L634-
A.10.26

To: **After Sales Official Network**
Subject: **Lambda sensor cable tie replacement**
Date: **21/04/2026**
Pages: **4**

Campaign name:
Lambda sensor cable ties replacement

Model:
Temerario

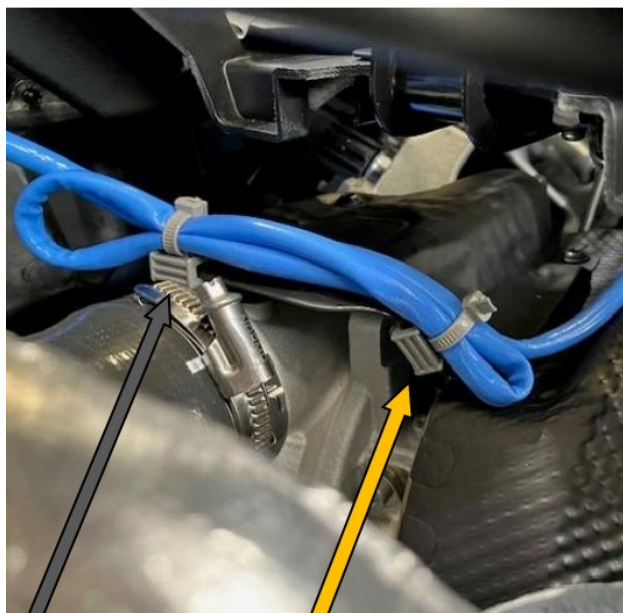
If the car has the following configuration with two cable ties that holds lambda sensor tie for each side, please select operation A. No more operations is necessary to do; in other cases please proceed with operation B

Racing hood - lightened version (Optional) – Disassembly procedure

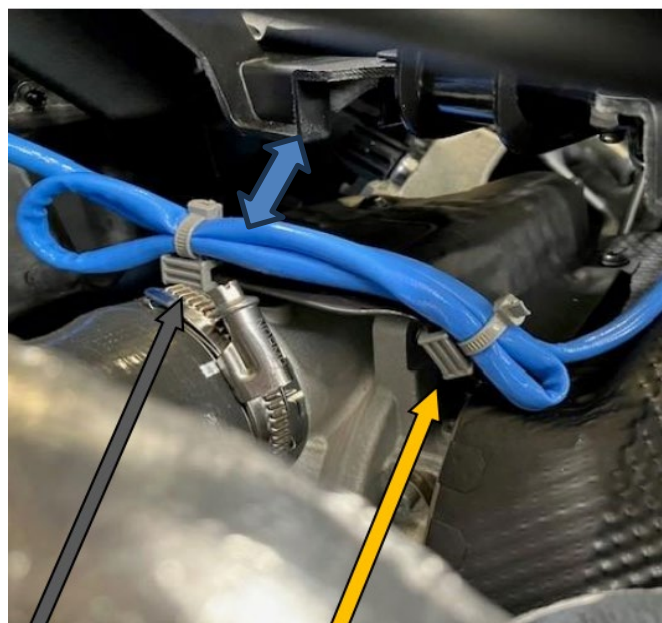
For Lightened version:

Then for both version install the two cable ties 6R0971497 for each side carefully to keep distance with the hinge and heat resistant shield

On the right side stay rear by the vent pipe
